City of Oregon City
South End Road Waterline Replacement
CI 15-012

ADDENDUM NO. 1
Issued: June 5, 2017

1. Sheet 10 (Drawing No. W08), Water Main Plan and Profile (STA 1+00B – 3+45B)

2. Sheet 11 (Drawing No. W09), Water Main Plan and Profile (STA 3+45B – 6+38B)

DRAWING NUMBER:
W08
SHEET 10 OF 16

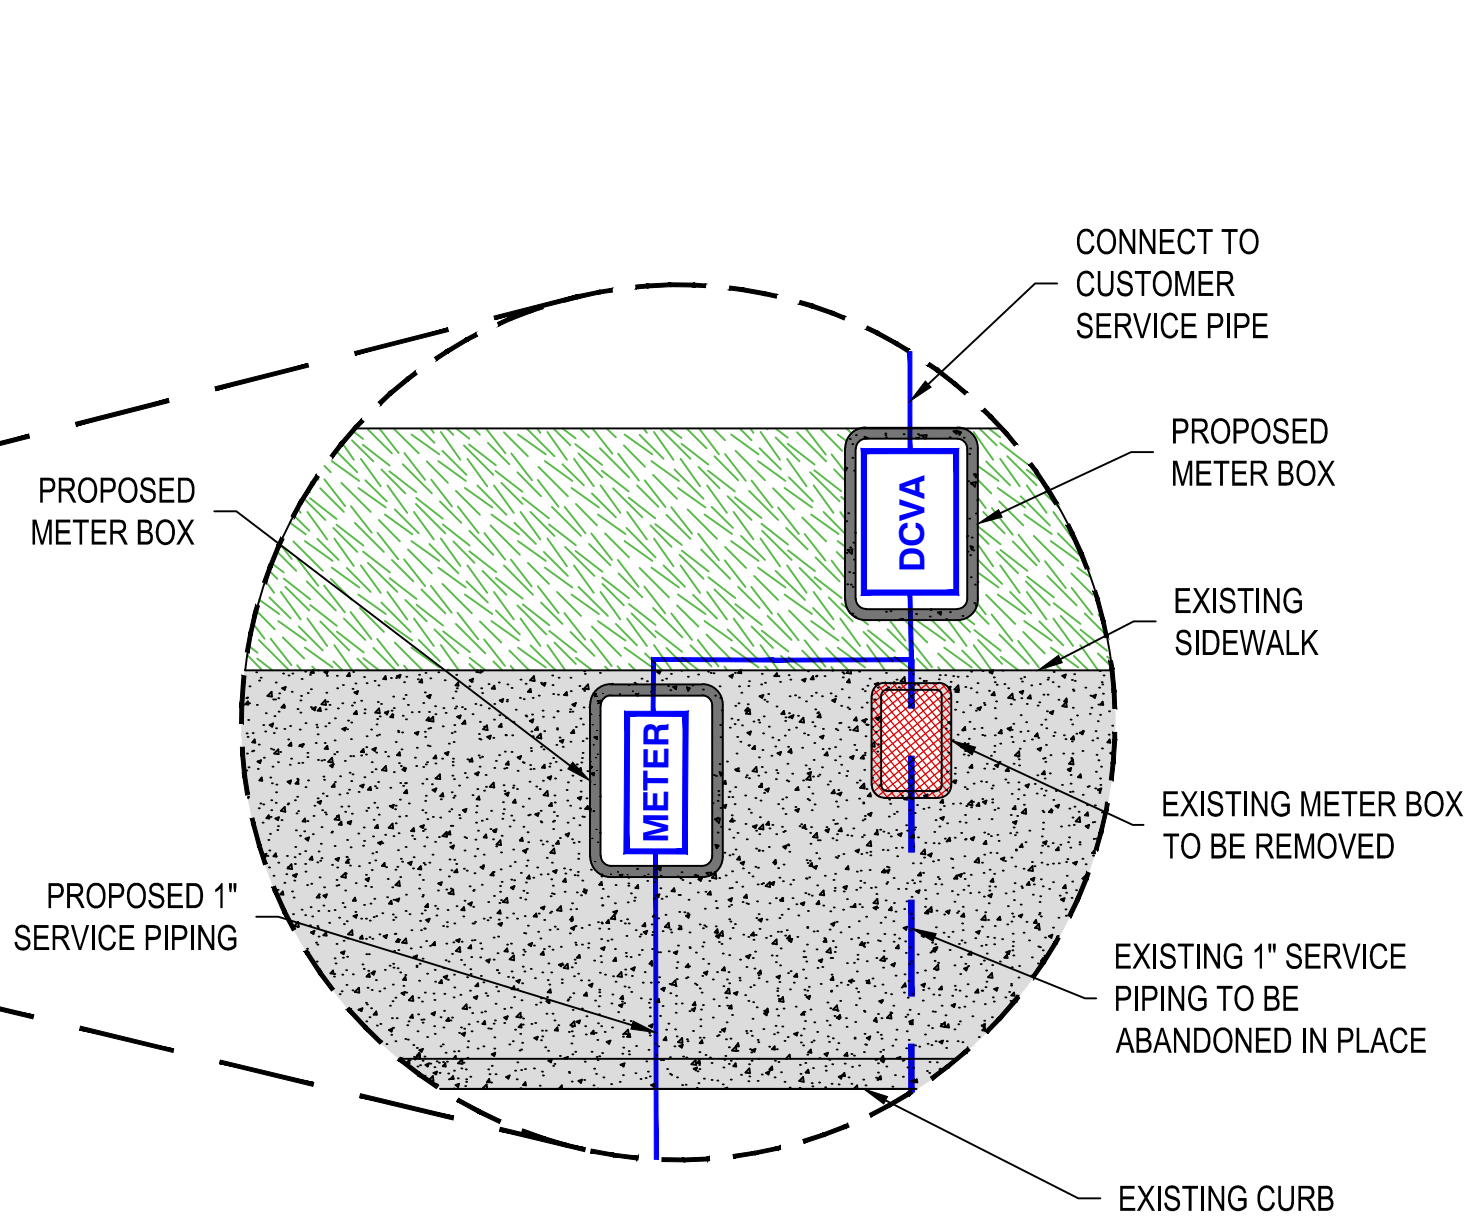
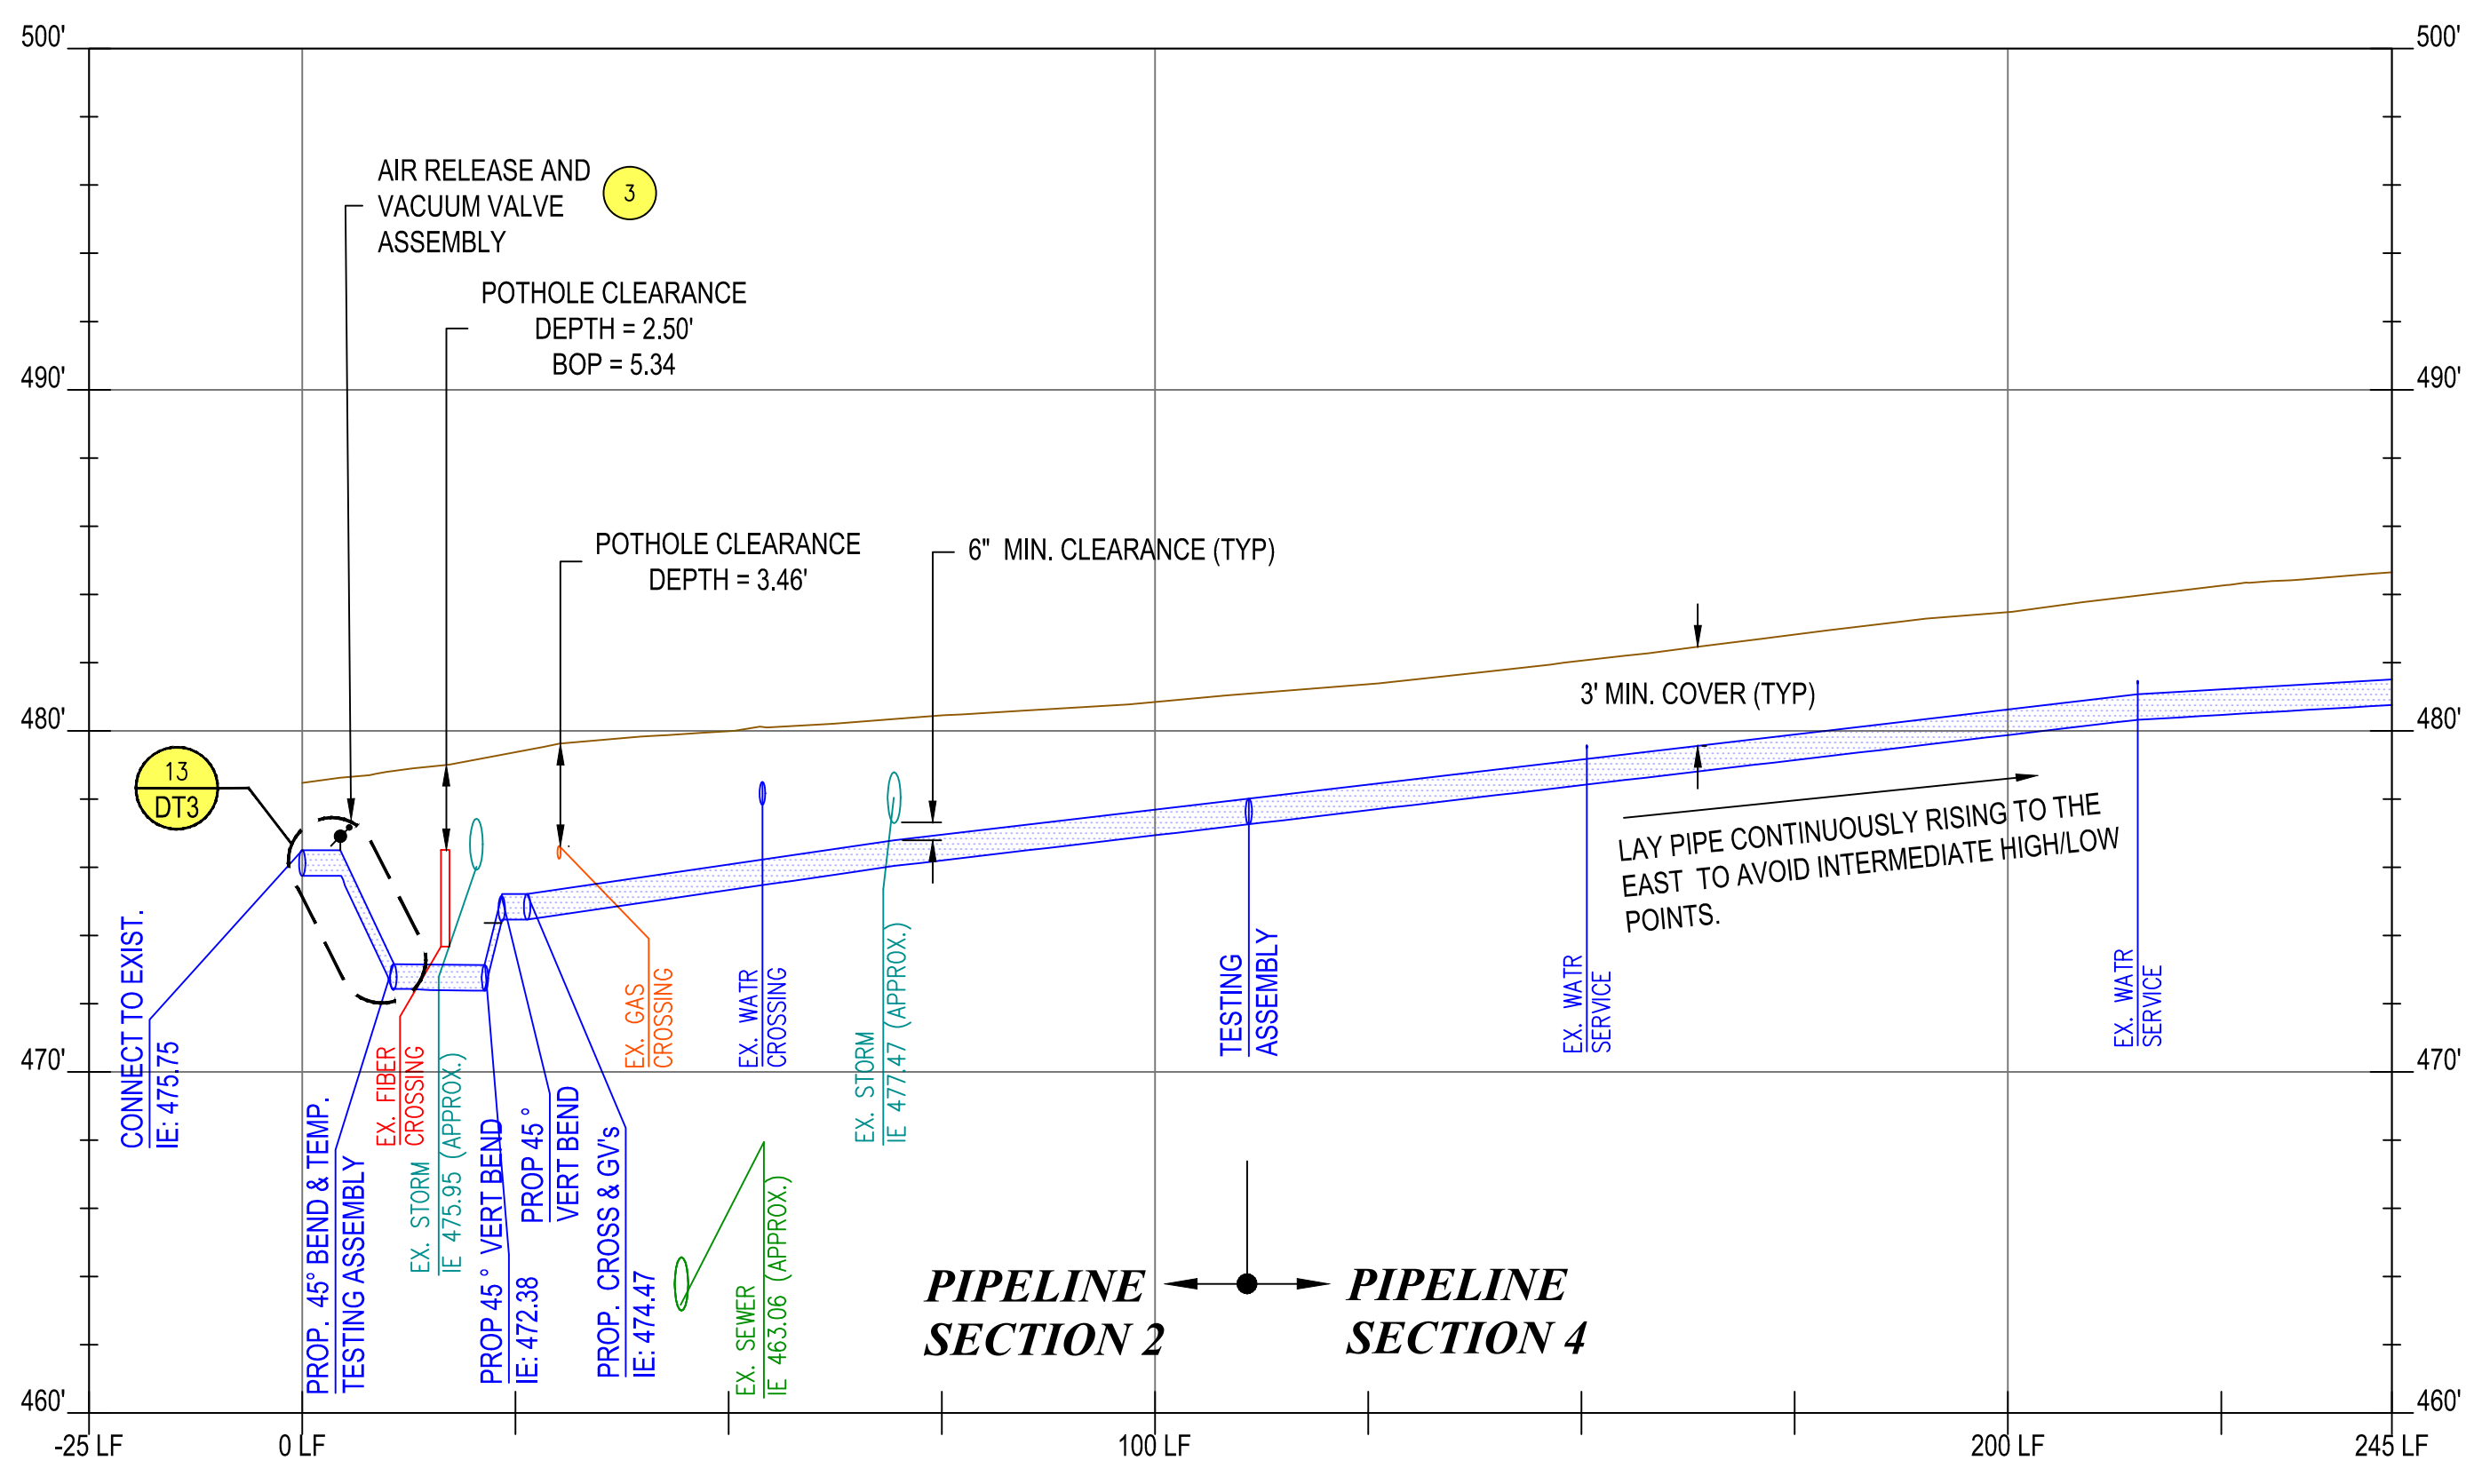
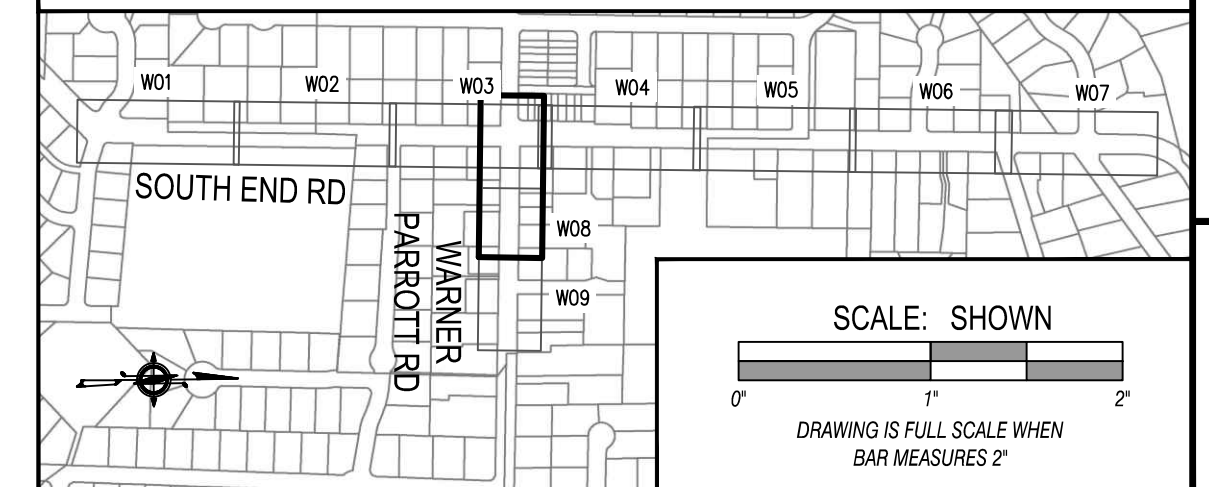
- (a) Replace Sheet 10 (Dwg No. W08) with the attached replacement sheet. The drawing has generally been revised as follows:
1. Revised Water Service #144 to add a 1-inch Double-Check Valve Assembly after the proposed water service, per Detail 1/W08.
 2. Added Detail 1 - Double Check Valve Assembly.
 3. Corrected station location callouts for water system fittings and services.

- NOTE:
- DCVA MUST BE APPROVED BY THE FOUNDATION FOR CROSS-CONNECTION CONTROL AND HYDRAULIC RESEARCH AT THE UNIVERSITY OF SOUTHERN CALIFORNIA.
 - SERVICE MUST BE INSTALLED AND CONNECTED PER PLUMBING CODE.

- 144 APPROX. STA 2+44.8B, 24.7L, PROVIDE:
(1) - 1" WATER SERVICE, COPPER
w/ 1" DOUBLE CHECK VALVE ASSEMBLY
- 145 APPROX. STA 3+06.8B, 27.0L, PROVIDE:
(1) - 1" WATER SERVICE, COPPER
- 146 APPROX. STA 2+70.2B, 23.3R, PROVIDE:
(1) - 1" WATER SERVICE, COPPER
